UNITED STATES PATENT AND TRADEMARK OFFICE

APPLICATION NO.	FILING DATE	FIRST NAMED INVENTOR	ATTORNEY DOCKET NO.	CONFIRMATION NO.
10/675,088	09/30/2003	Jung-Seon Park	CU-3336 VE	4762
26530	7590	02/16/2007	EXAMINER	
LADAS & PARRY LLP 224 SOUTH MICHIGAN AVENUE SUITE 1600 CHICAGO, IL 60604			KARLS, SHAY LYNN	
			ART UNIT	PAPER NUMBER
			1744	
SHORTENED STATUTORY PERIOD OF RESPONSE		MAIL DATE	DELIVERY MODE	
3 MONTHS		02/16/2007	PAPER

Office Action Summary

DETAILED ACTION

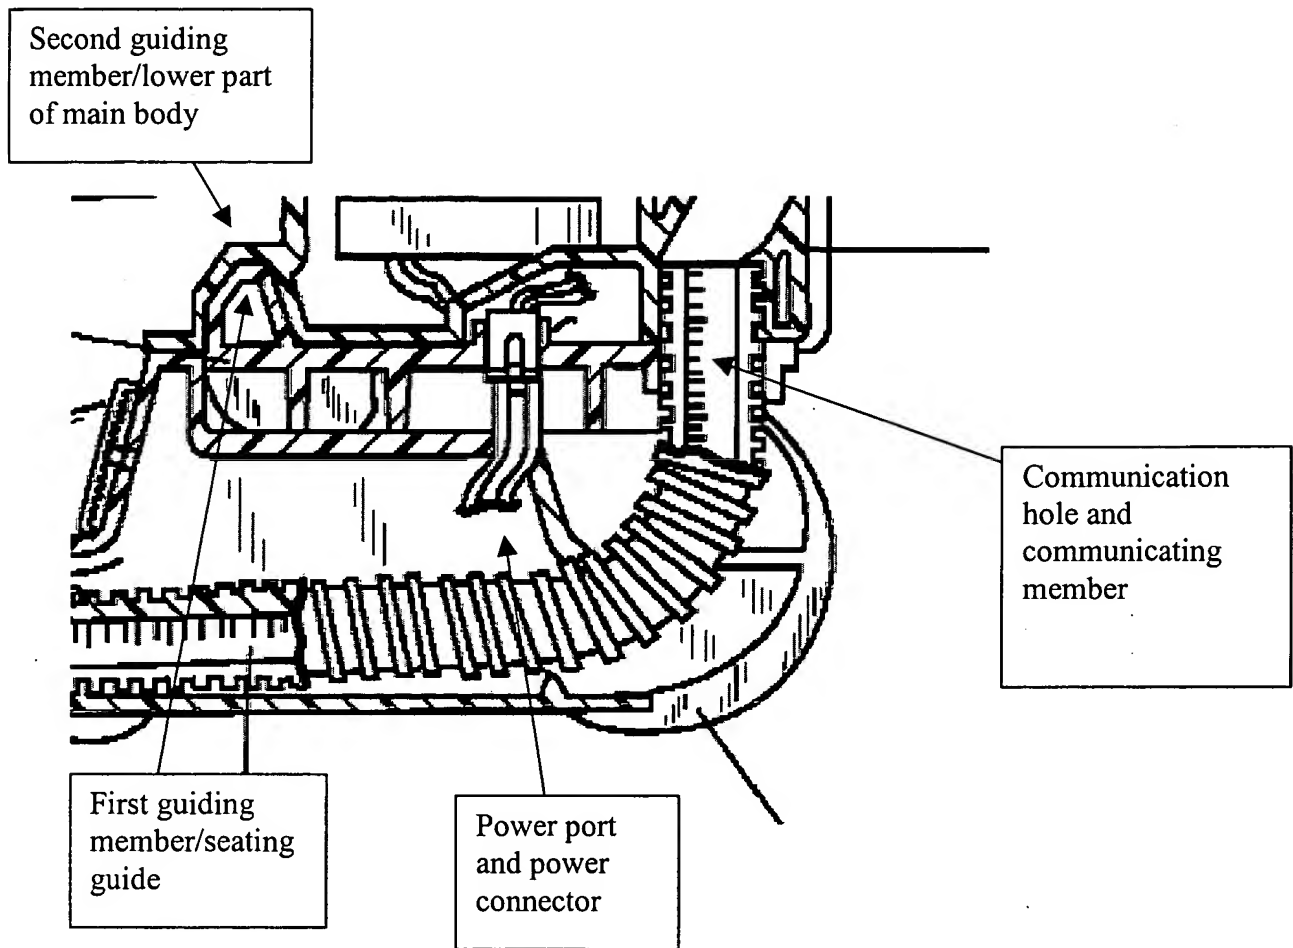
With regards to claim 10, the connecting portion comprises a communication hole (not labeled, see figure 6, what 94 connects to) through which the air drawn in through the nozzle assembly is directed to the main body of the vacuum and a communicating member (94) connected to the communicating hole is formed at the main body of the vacuum (see figure below)

With regards to claim 11, there is a power port on one side of the connecting portion for providing power from the main body and a power connector disposed on the lower part of the main body to be connected to the power port (not labeled but shown on figure 6 to the left of the communication hole) (see figure below).

With regards to claim 12, there is a first guiding member on the connecting portion and a second guiding member corresponding to the first guiding member on the lower part of the main body (see figure below).

With regards to claim 13, the first guiding member is shaped in to a convex protrusion (cross section shows a convex shape in figure below) and the second guiding member is shaped in to a concave groove (cross section shows a concave groove in figure below).

With regards to claim 15, there is a seating guide on the connecting portion corresponding to the lower part of the main body of the vacuum cleaner (see figure below).

With regards to claim 16, the seating guide is shaped as a convex protrusion (cross section shows a convex shape in figure below) and the lower part of the main body is shaped as a concave groove (cross section shows a concave groove in figure below).
